<b>Docket Number:</b>	19-SPPE-03
<b>Project Title:</b>	Sequoia Data Center
<b>TN #:</b>	231257
<b>Document Title:</b>	C1 Responses to CEC Staff DR Set 3
<b>Description:</b>	N/A
<b>Filer:</b>	Scott Galati
<b>Organization:</b>	DayZenLLC
<b>Submitter Role:</b>	Applicant Representative
<b>Submission Date:</b>	12/16/2019 5:20:57 PM
<b>Docketed Date:</b>	12/17/2019

# RESPONSE TO CEC STAFF DATA REQUEST SET 3 (106-118)

Sequoia Backup Generating Facility (19-SPPE-03)

**ENLARGED SITE PLAN**

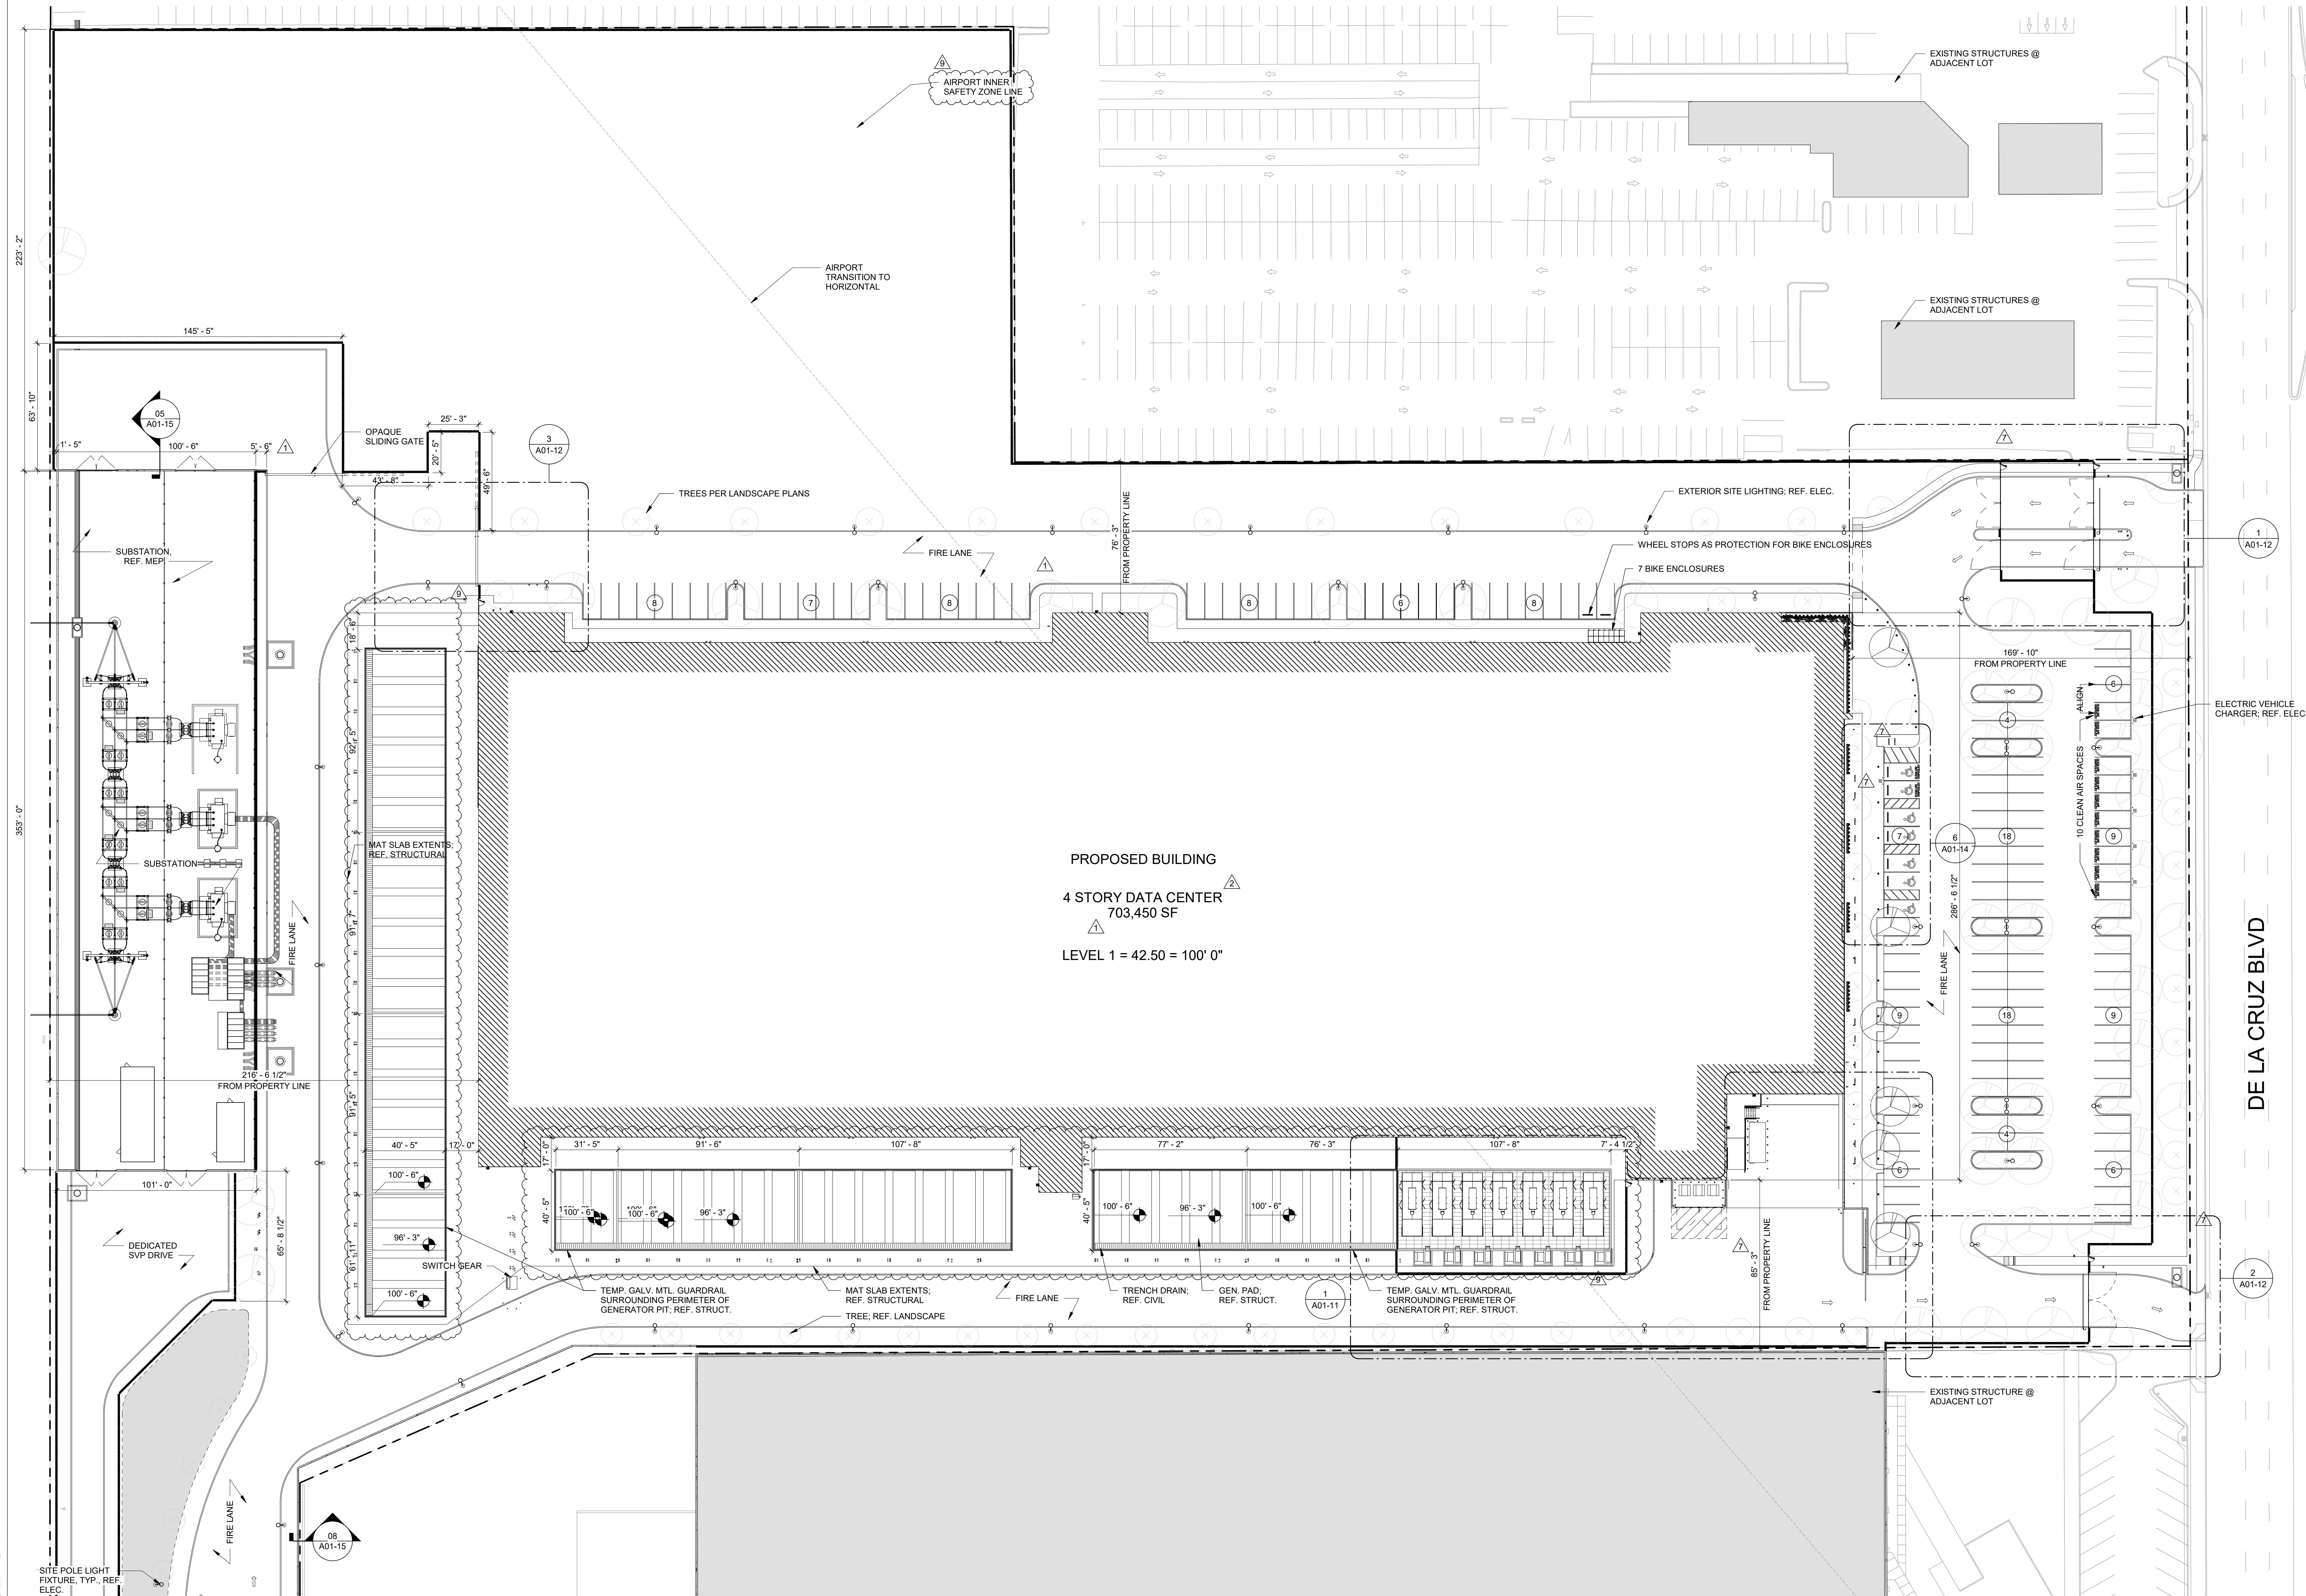
108. Please describe the dimensions of the concrete basin that would be necessary for the underground fuel storage tanks, including depth and volume of excavated material.

Generally the concrete basins are shown on the enlarged site plan drawing included in Appendix PD DR-108 and are 5.2 feet deep. The volume is estimated to be approximately 154,000 cubic feet.

### **Cross-Section of Below Grade Tank Basin**

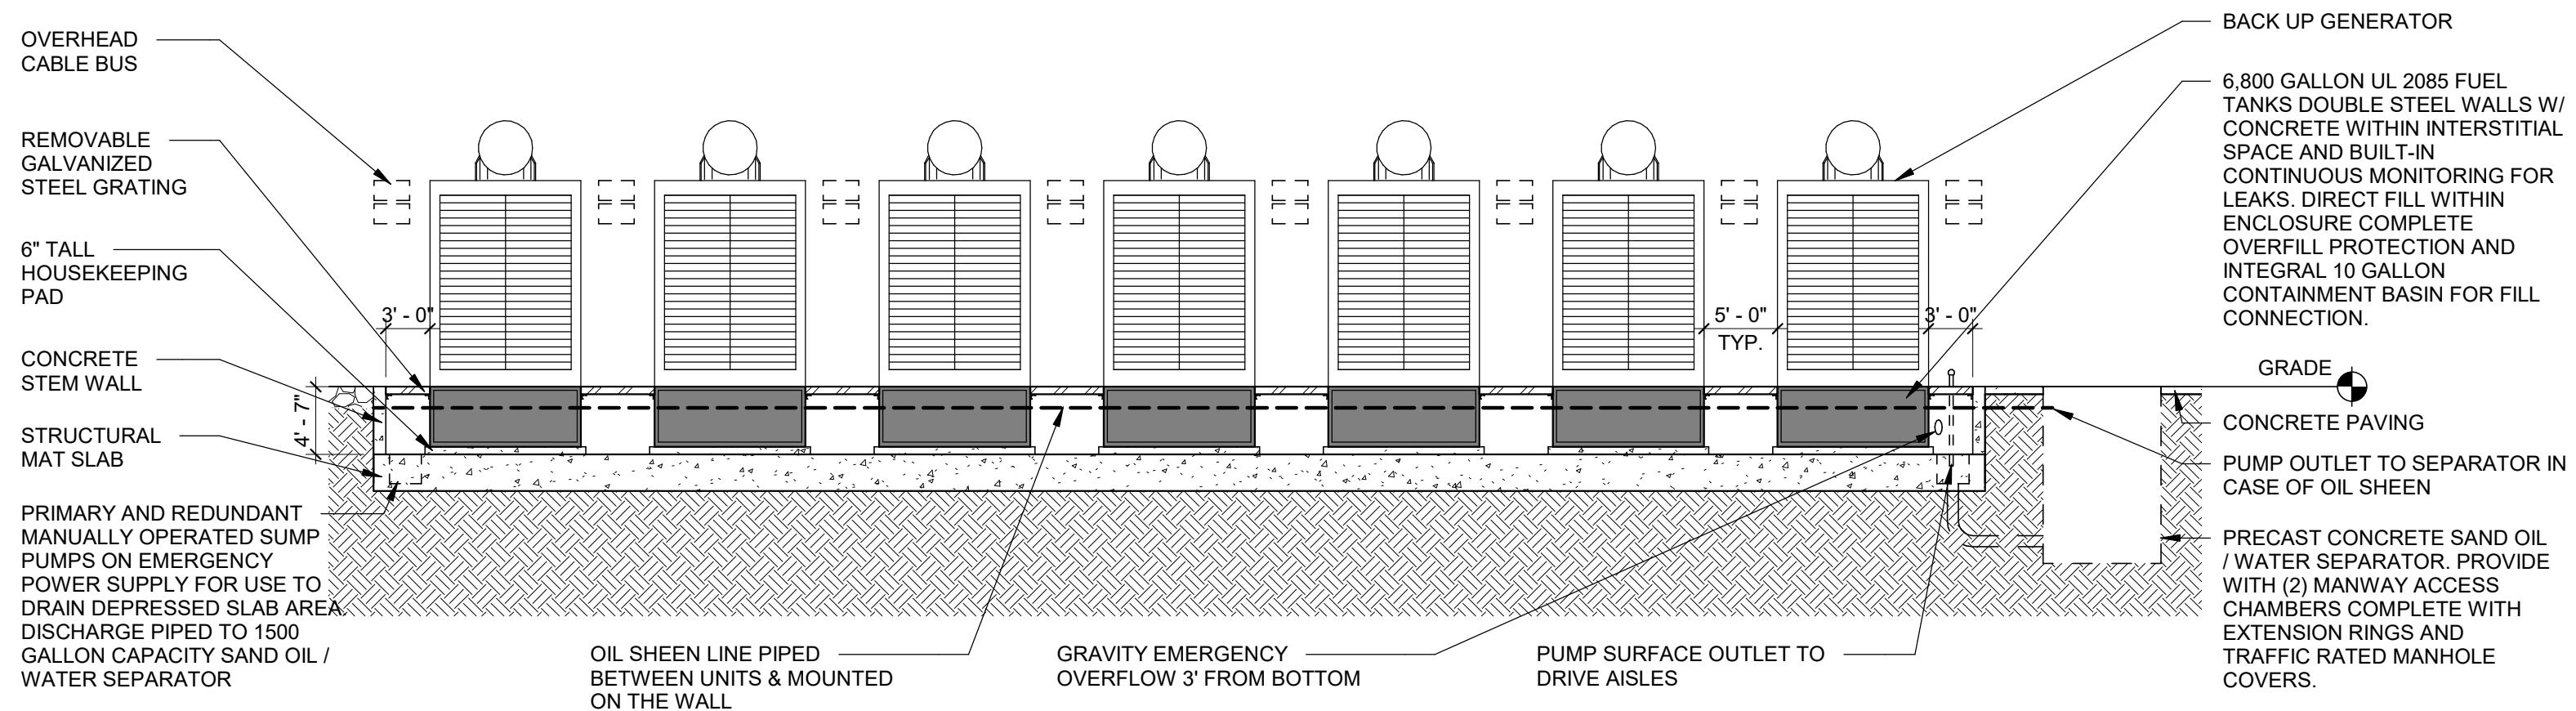
109. Please include an updated project description to include the underground fuel storage tank basins, and the operation and maintenance of the underground basins.

Please Appendix PD DR 109 for a detailed drawing showing a cross-section and notes describing the concrete basin.

The fuel tanks will be located in a recessed concrete pit with the top of the tank matching adjacent grade. The top of the tank will be covered by the generator and enclosure integral to the generator system. Each tank will be independent of each other and dedicated to a single generator. Tanks will be UL 2085 fire rated constructed of double wall steel and concrete interstitial space. Leak detection will be provided in the interstitial space. High fill alarms will be included and there will be no piping provided between tanks. Personnel platforms will be made between tanks at the bottom of the generator platforms out of galvanized steel or FRP. The concrete basin will be designed to collect storm water with a sump pump.
